SPECTRO3-MSM-DIG-Scope: Changes due to software update from V1.3 to V1.4

This manual summarises the changes that were made with the software update from **SPECTRO3-MSM-DIG V1.3 to V1.4**.

Change 2:

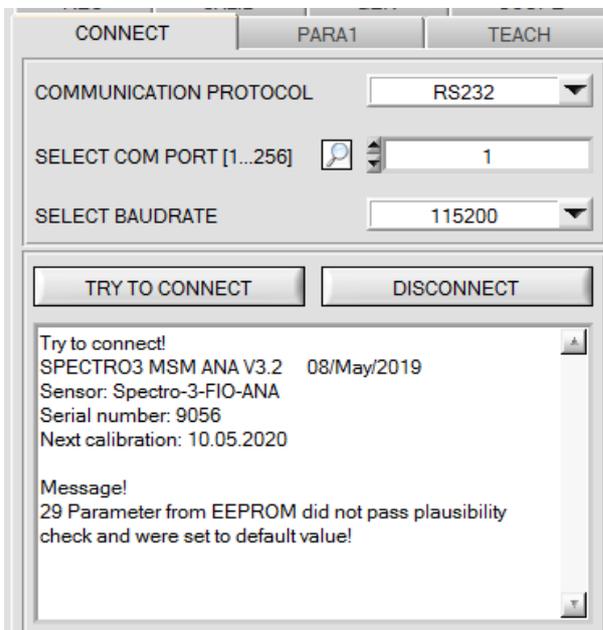
The newly added LED SAT indicates if one of the channels is in saturation. In this case, it lights up red.
